SERVICE BULLETIN 89-1

SUPER LOOPS

SERVICE BULLETIN 89-2A

Bulletin No.: L03-001  
Release Date: 02/24/03  
Effective Date: Immediately  
Supercedes: N/A  
Completion Date: 03/31/03  
Page: 1 of 4

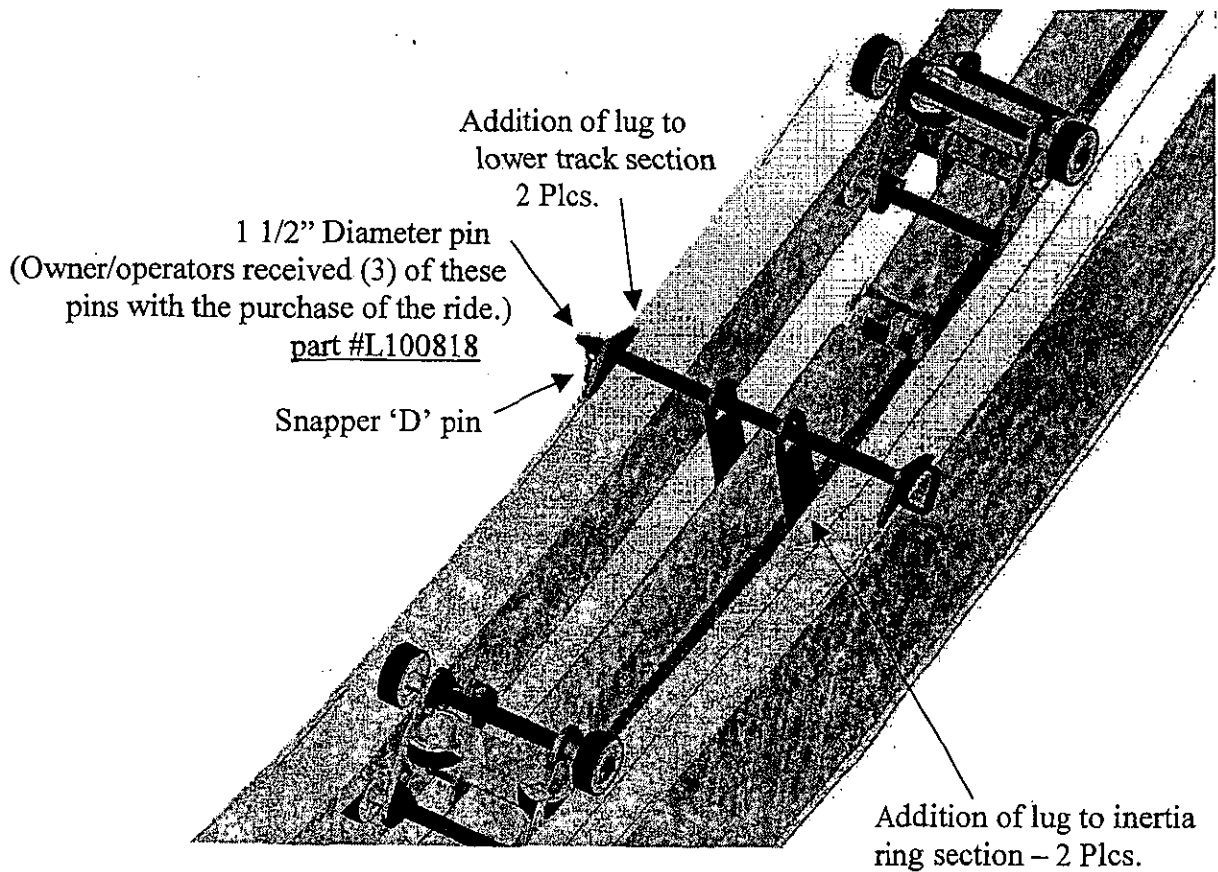
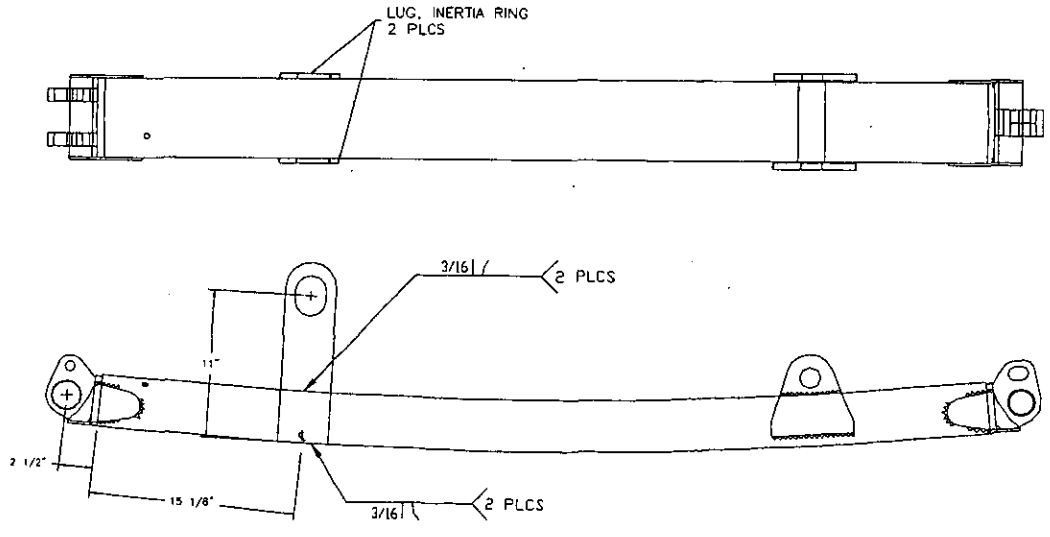
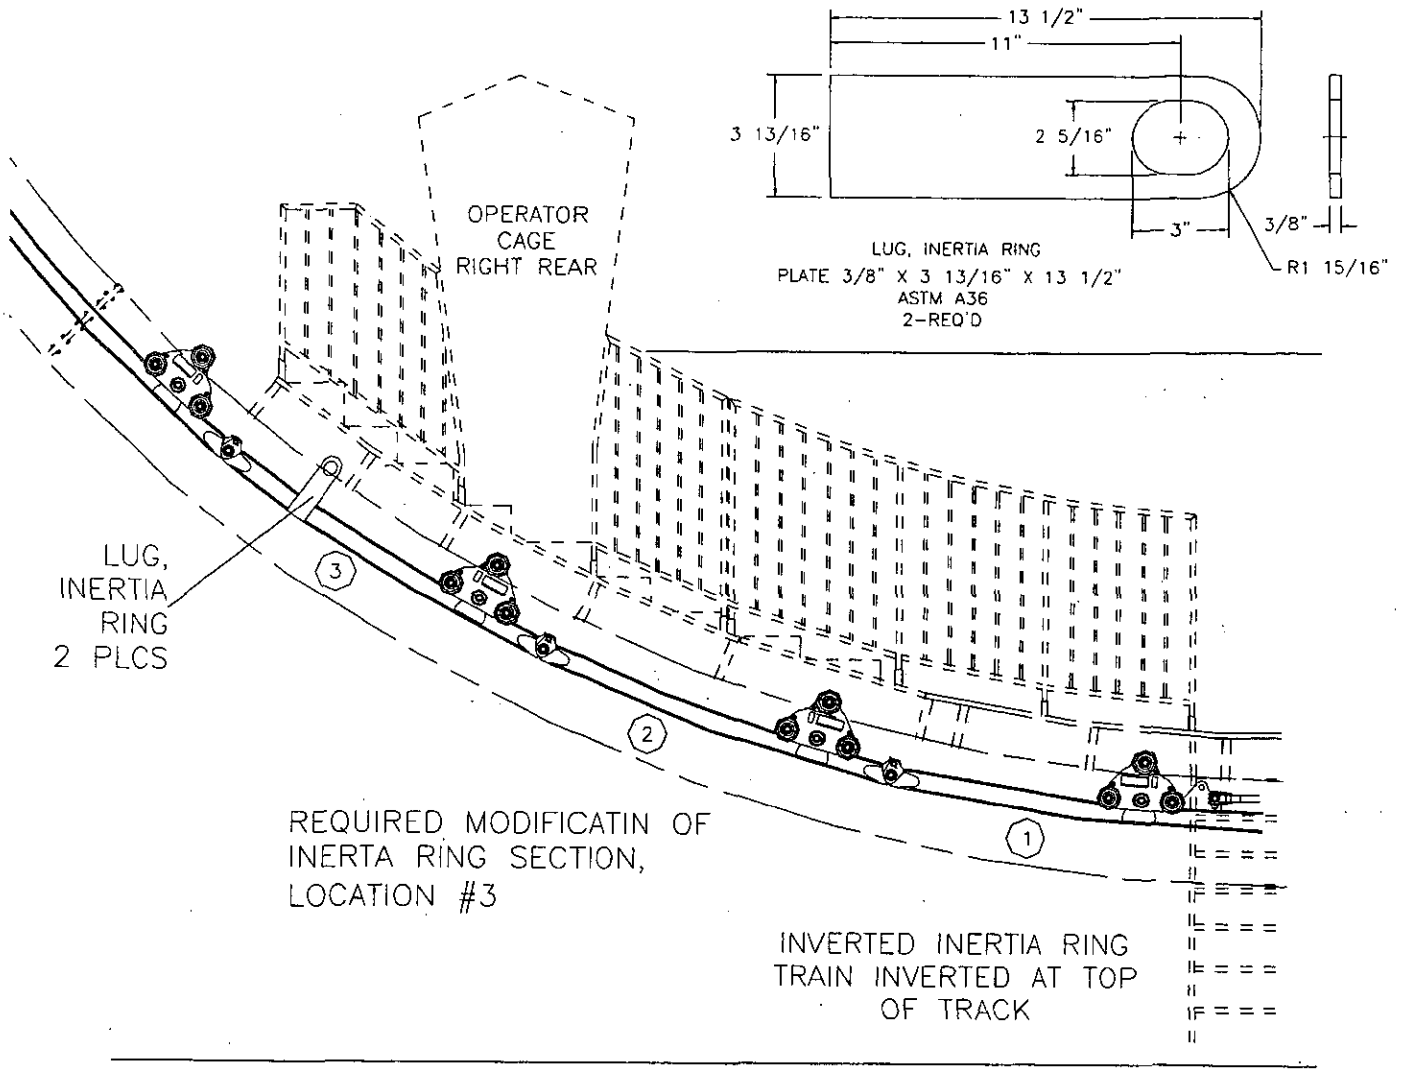
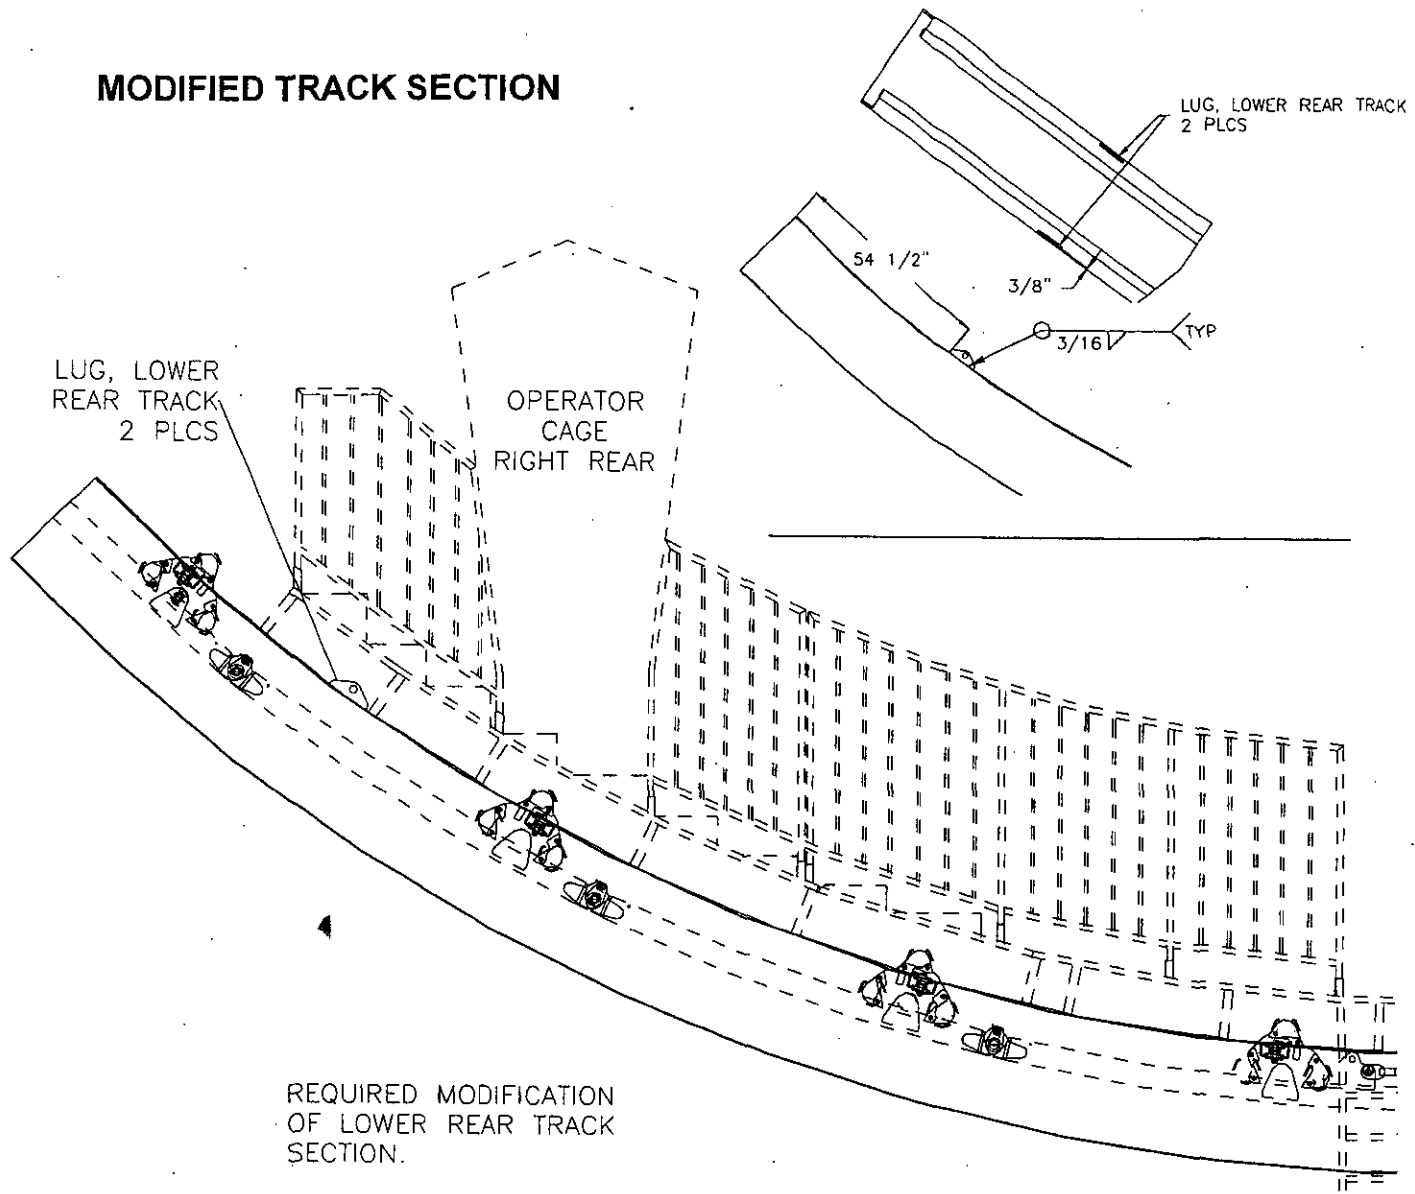
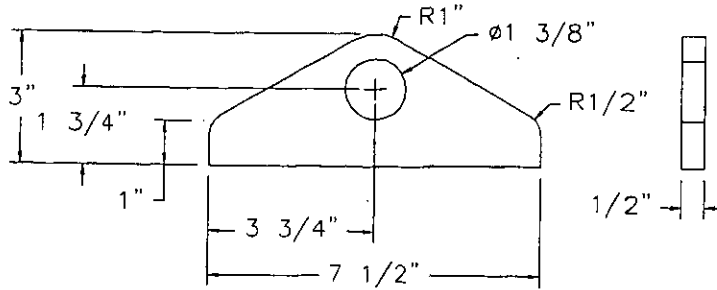
Addition of a positive lock to secure the train in an inverted position in order to increase safety during the inspection process.

In order to properly inspect and maintain the ride, the train needs to be stopped in an inverted position. Movement of the train during inspection may result in serious injury or death. This method to positively lock the train increases safety during required inspection and maintenance.

Add inverted positive lock.

Components for this inverted positive lock may be purchased from Larson International, Inc. or may be manufactured by the owner/operator in compliance with the following drawing specifications.

A certified welder must complete all welds.

LUG, LOWER REAR TRACK  
PLATE 1/2" X 3" X 7 1/2"  
ASTM A36  
2-REQ'D

Bulletin No.: L03-002  
Release Date: 02/24/03  
Effective Date: Immediately  
Supercedes: N/A  
Completion Date: N/A  
Page: 1 of 2

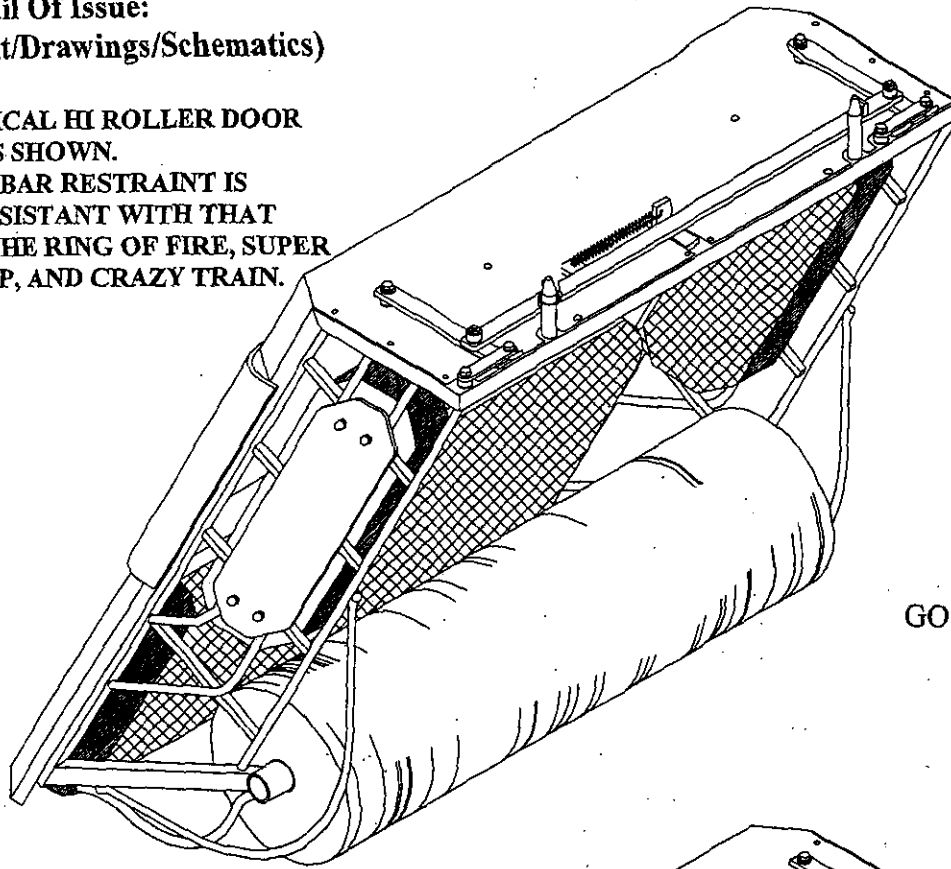
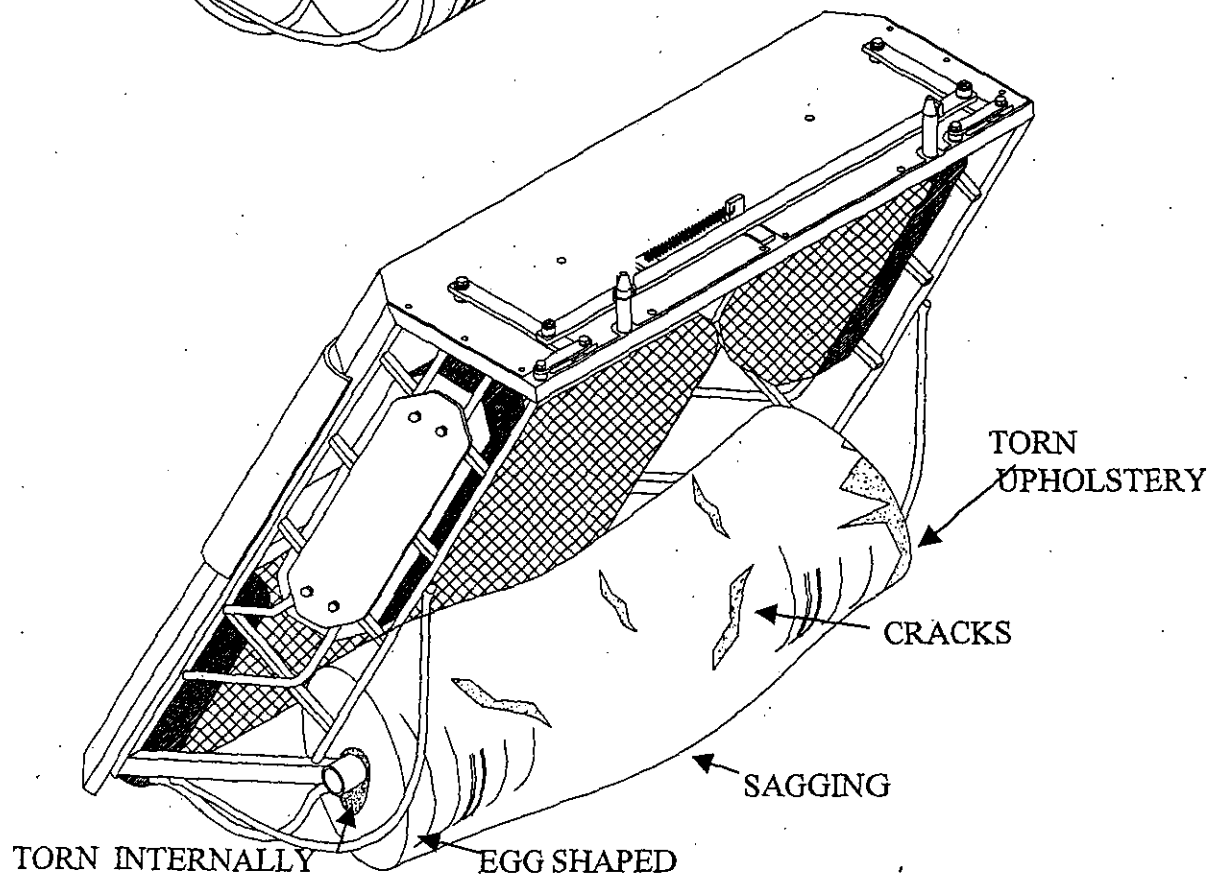
**Abstract Of Issue:**  
**Mandatory daily inspection of lap bar padding.**

**Reason for Release:**  
**Certain operators have allowed rides to operate despite severely worn lap bar padding. This poses a threat of injury or death if the riders are not properly restrained due to worn padding.**

**Action To Be Taken:**  
**Inspect lap bar padding on a daily basis. Replace padding if:**

- 1. The foam padding does not hold its memory.**
- 2. The foam padding is worn or torn to the point it will not hold a passenger in their seat firmly.**
- 3. The foam padding is torn internally such that the padding hangs or sags from the shaft that is to run through the center of the padding.**
- 4. The foam padding is egg-shaped or sagging and is no longer cylindrical in shape.**

**Minor damage to the upholstery cover is permissible as long as it does not pose a threat to passenger safety.**

## STEP EIGHT

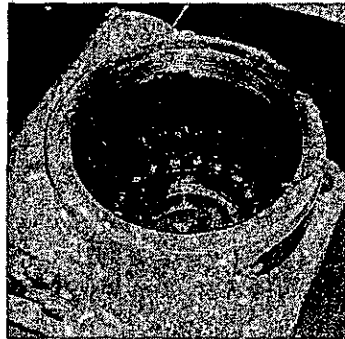
Remove bearing and actuator brass gear and inspect threads on gear. Degrease and inspect brass gear and bearing.

**WARNING:** Replace brass gear if threads are less than  $3/16''$ .
